WATTS BAR NUCLEAR PLANT UNITS 1 AND 2
RUSKIN FIRE DAMPERS
NCR WBN MEB 8008
10 CFR 50.55(e)
FINAL REPORT

Description of Deficiency

CHANGE LETTER	REVISION DESCRIPTION		CHK BY	APP'D BY	DATE
DATE 3-27-80	DATE 3-27-80	DATE 4-2-80	RUSKIN Mfg. Co.		DATE
P.O. Box 123			Grandview, Mo. 64020		DATE
TITLE			VERTICAL NIBD 23 SPRING BRACKET MODIFICATIONS		DATE
			5564		DATE

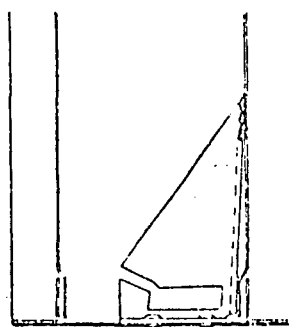
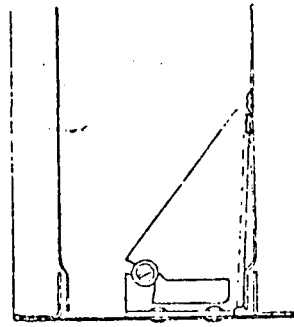
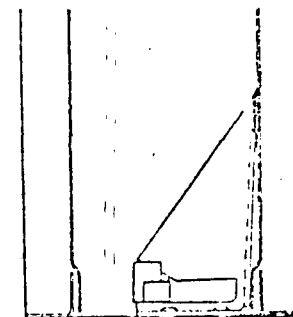
In our response to NRC on NCR WBN MEB 8007 (formally MEB 80-04), we addressed a problem relating to Ruskin's vertical, spring closure, NIBD23 Fire Dampers and a fix or correction was suggested which consisted of fastening a #6 screw in the narrow portion of the slot in the spring brackets.

Although it appears that this method should have eliminated the problem, an engineering firm has indicated to us that some of the screws worked loose during shipment. This raises the possibility that the use of screws as a fix is questionable.

ORIGINAL FIX USING
#6 SCREW, WASHER, STAR
LOCKWASHER & HEX NUT

Ruskin has now developed an alternate fix consisting of a small metal clamp which attaches to the spring bracket and provides a positive stop for the spring (see drawing 5564).

TOP EDGE OF BRACKET
TACKWELDED TO PROVIDE
EXTRA SUPPORT FOR
BRACKET & RESULTING
ALTERATION OF SPRING
SLOT

INSTALLATION OF
PROPOSED BRACKET
CLAMP (SEE DETAIL
ABOVE ALSO)

BRACKET WITH CLAMP
INSTALLED

CHANGE LETTER	REVISION DESCRIPTION	OWN. BY	APP'D BY	DATE
DATE	DATE	DATE	RUSKIN Mfg. Co.				SCALE
3-25-80	5-28-80	4-2-80	P.O. Box 125 Grandview, Mo. 64030				ISSUE
			TITLE				DWG. NO.
			VERTICAL NIBBERS (9" HIGH 11112 1555) CLOSURE				5565

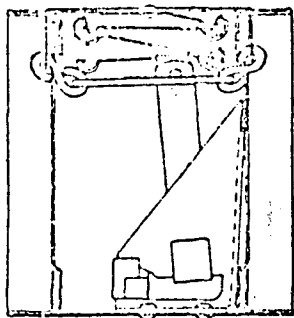
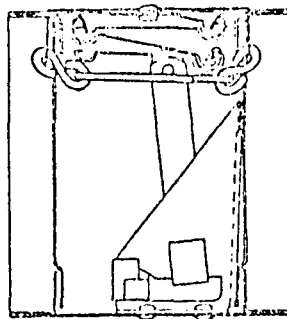
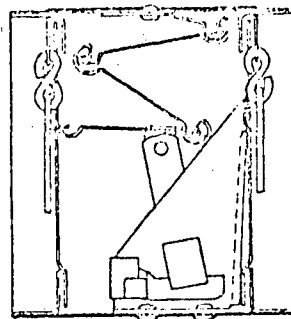
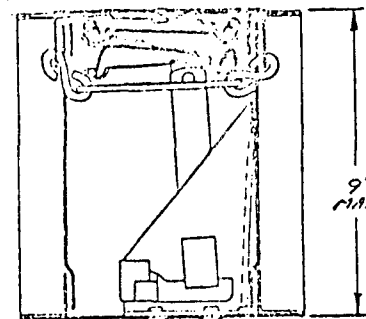
A second problem has also been brought to our attention. If the blade package in vertical units less than 9" high is shifted such that the leading edge of the bottom blade rests higher than the trailing edge, the blades may jam when released.

ABOVE, THE BLADE PACKAGE
HAS BEEN SHIFTED ALLOWING
THE LEADING EDGE OF
THE BOTTOM BLADE TO BE
ABOVE THE TRAILING
EDGE - IF THE FUSE
LINK MELTS WITH THE
BLADES IN THIS POSITION,
THEY WILL JAM AS IN
THE NEXT DETAIL

BLADE PACKAGE JAMMED

Ruskin has developed a snap-in strip which when installed will hold the bottom blade in the proper orientation and ensure complete and consistent closure (see drawing 5565).

VERTICAL NIBBERS
AS SHOWN, THE DAMPER
WILL CLOSE COMPLETELY
AND CONSISTANTLY WHEN
THE FUSE LINK MELTS

DAMPER WITH SNAP-IN
STRIP (SHOWN AT RIGHT)
INSTALLED. SINCE LEADING
EDGE IS HELD BELOW
TRAILING EDGE ON BOTTOM
BLADE, UNIT CLOSSES
COMPLETELY & CONSISTANTLY

.030" \pm $\frac{1}{4}$ " WIDE ST. STL.

SNAP-IN STRIP INSTALLED
ON BOTTOM BLADE
